DR 999-1002 REHABILITATION PACKAGE

Job No.: 15-4605

ADDENDUM 1

October 4, 2017

10/03/2017	ENGINEERS
REVISIONS	
DR 999-1002 REHABILITATION PACKAGE	
QUANTITIES	
DEVELOPER:	
CONT.	BUDGET PROJ.
SUBMITTED _____	
APPROVED _____	
MAP NO. -	SHEET
SECT. NO.	3
DR. ES CH. MSG	JOB NO. 15-4605 OF 38

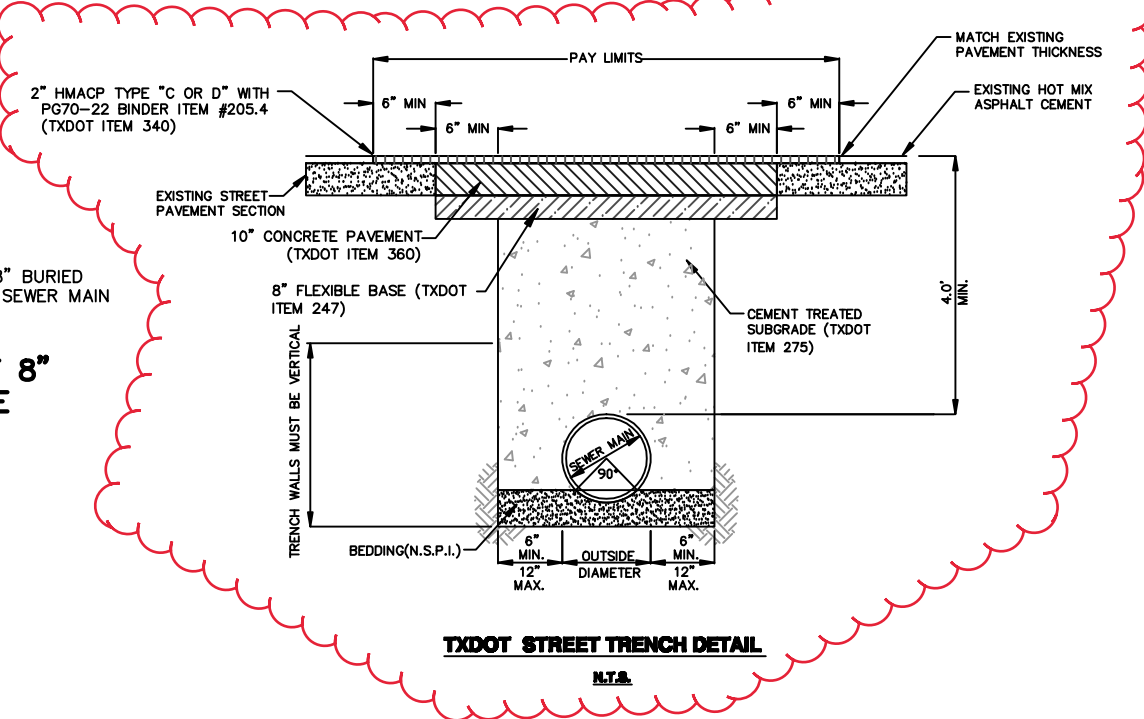
2. Remove and replace the Overall **Plan Quantity Sheet** (Sheet 3) within the plans with the attached Plan Quantity Sheet.

Quantities Updated

Item 866 SEWER MAIN PRE-TELEVISION INSPECTION 9,701 LF

Item 900 RECONSTRUCTION OF 8" SANITARY SEWER BY PIPE BURSTING REPLACEMENT PROCESS (ALL DEPTHS) 5,537 LF

ITEM 866 SEWER MAIN PRE-TELEVISION INSPECTION INCREASED BY 330 LF FOR A TOTAL OF 9701 LF

ITEM 900 RECONSTRUCTION OF 8" SANITARY SEWER BY PIPE BURSTING REPLACEMENT PROCESS (ALL DEPTHS) INCREASED BY 330 LF FOR A TOTAL OF 5537 LF

MAP NO. — SHEET 9 OF 38
 SECT. NO. —
 DR. ES CH.MSG JOB NO. 15-4605

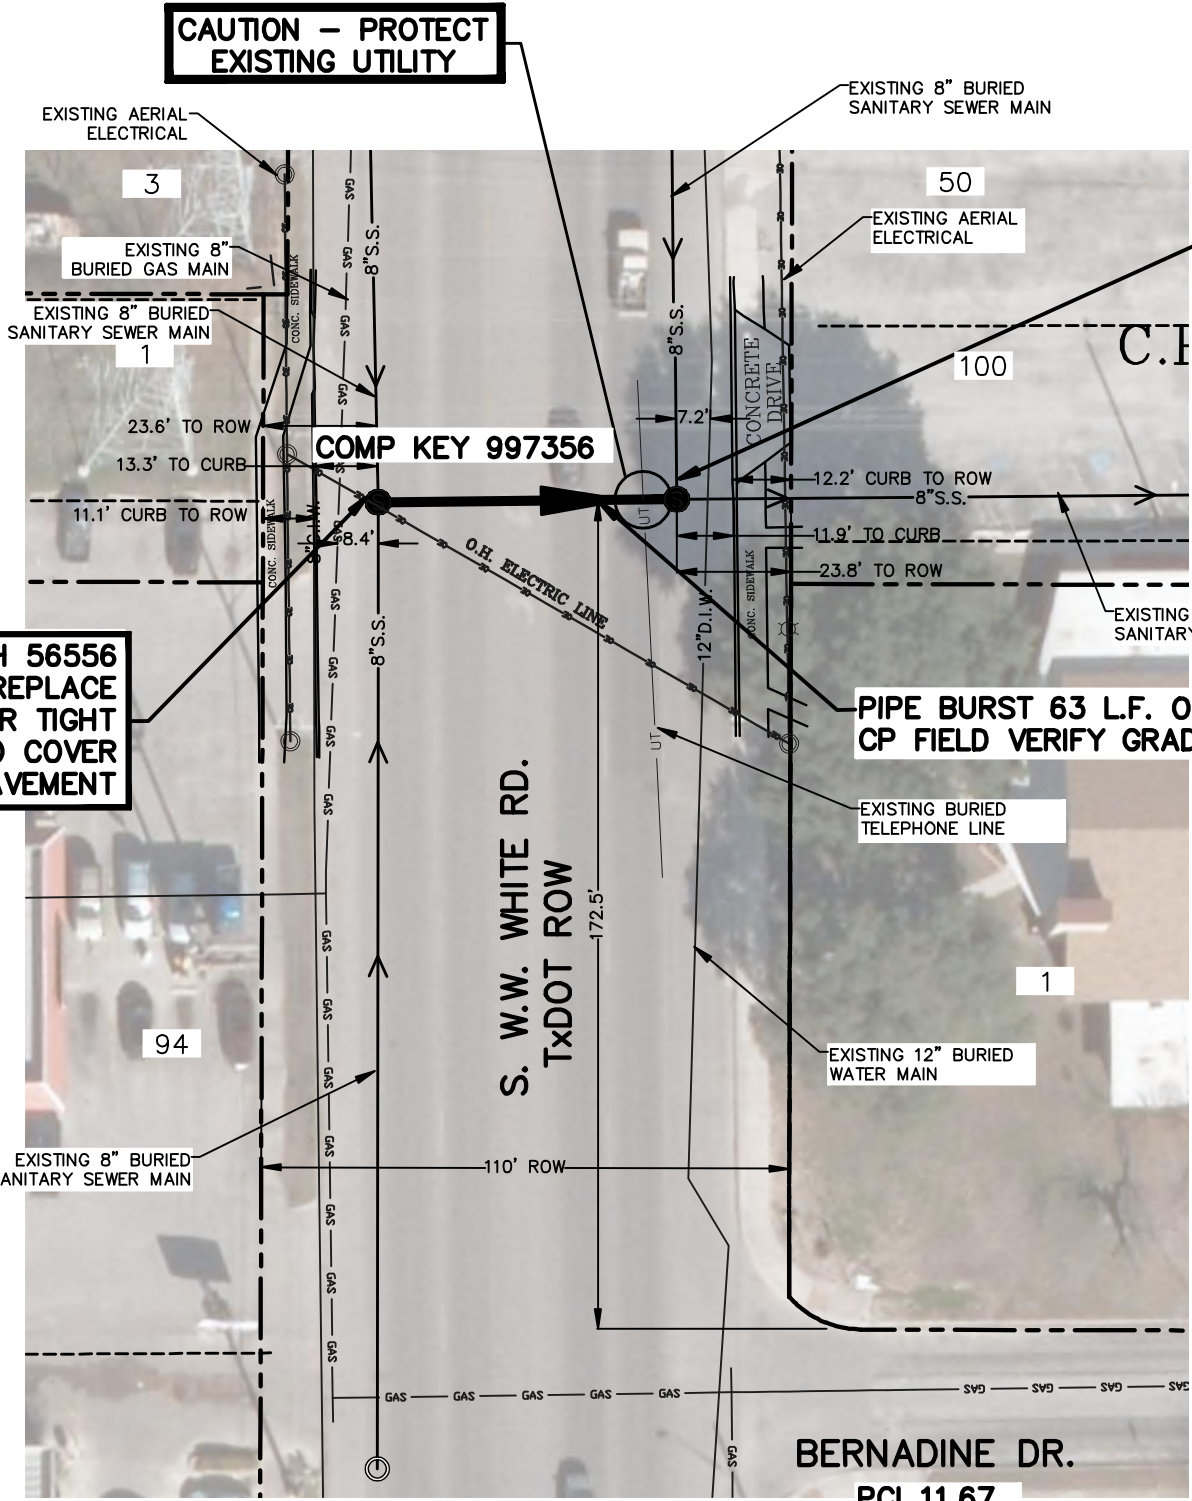
3. Remove and replace **Plan Sheet 9 of 38** with Revised Plan Sheet 9 of 38 showing TxDOT Trench Repair Detail.
